Service Bulletin

Subject: Steering Shudder (Vibration) During Slow Speed Maneuvers

Models: 2010-2013 Chevrolet Equinox
2010-2013 GMC Terrain
Equipped with Engine RPO LF1, LFW or LFX

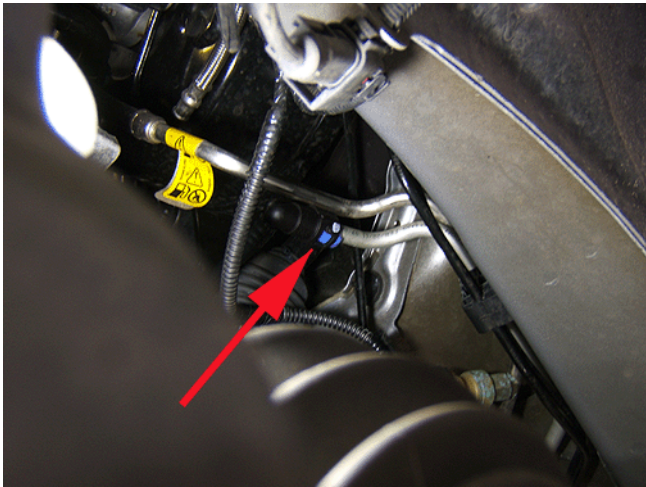
1. Install the revised generator. Refer to Generator Replacement in SI.
2. Install the revised power steering inlet hose. Refer to Power Steering Gear Inlet Pipe/Hose Replacement in SI. Leave the intake manifold cover off.
3. Install the revised evaporative emission canister purge hose assembly as follows:

- 3.1. Disconnect the hose from the evaporative emission canister purge solenoid valve located by the base of the throttle body.

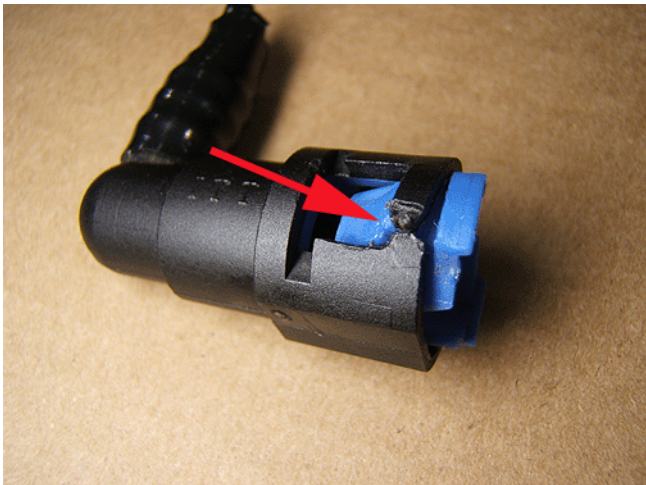
3.2. Disconnect the hose from the chassis to canister evaporative emission line.

It may be necessary to cut the plastic connector on the hose if the blue plastic retention collar cannot be released. A new connector is part of the new hose assembly.

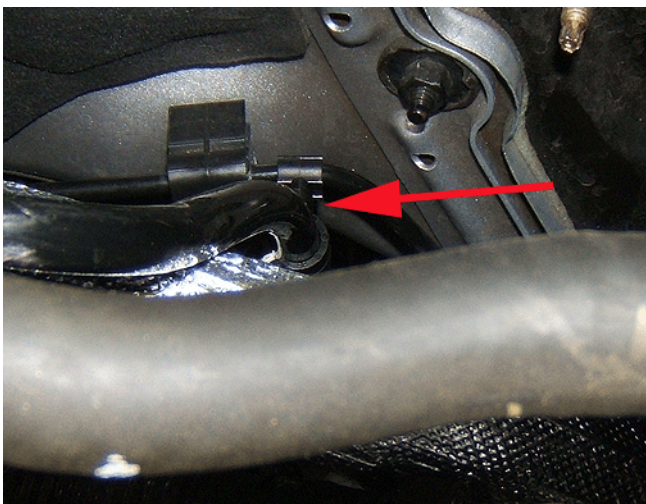
3.3. Remove the existing hose and install the new hose assembly.

Route the new hose in a way that avoids contact with chassis and body components. Connect both ends of the hose.

- 4.** Install the clip as shown, connecting the new evaporative emission canister purge hose assembly to the black metal cross car brake pipe.
- 5.** Inspect the new evaporative emission canister purge hose assembly and the revised power steering inlet hose to ensure no components are coming into contact with the new hose assemblies. If contact is present, loosen and reposition the new hose.
- 6.** Fill and bleed the power steering system. Verify the fluid level. Repeat the bleed procedure, if necessary.
- 7.** Reinstall the intake manifold cover.
